Department of Public Works

Comments

3774 S 27th St in the South 27th/Howard DIZ

August 6, 2025

National Flood Hazard Layer FIRMMette

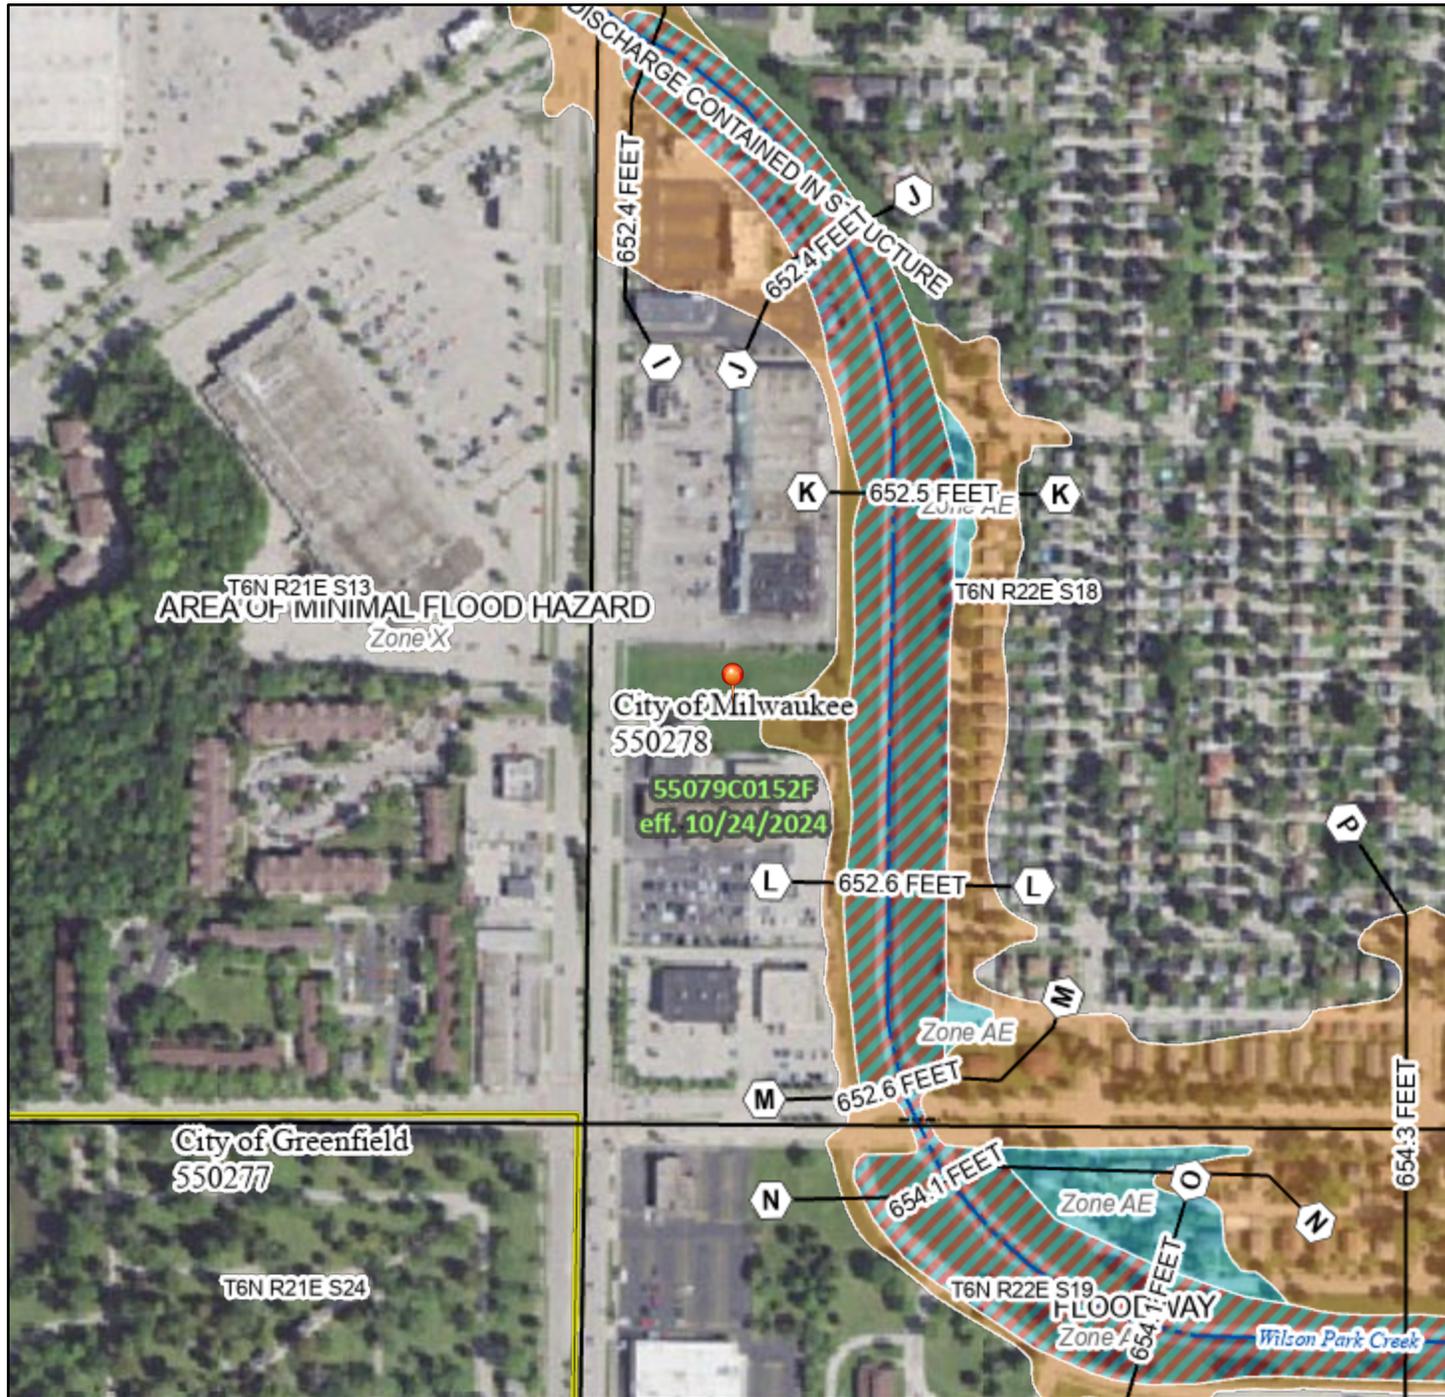
If no flood mitigation projects were to be built the future floodplain elevation at 3774 S 27th St would be approximately 657.75-ft, which is approximately the location of the 0.2% flood area shaded in orange on the attached Firmette. One mitigation project has already been completed behind Arlo Steel and another large mitigation project is planned to be built within Wilson Park. Once completed these projects could lower the future floodplain elevation at the property to an elevation of 653.23, which would result in the floodplain not extending onto this property.

Regardless of the future projects if this development is able to set the first floor elevations for the Banquette Hall and Retail Building to be at or above elevation 657.75, the structures would be outside of the future floodplain. At this time we do not have a clear timeline as to when the floodplain maps will be updated, it could be as early as spring of 2026, but 2027 or 2028 is a more realistic timeframe.
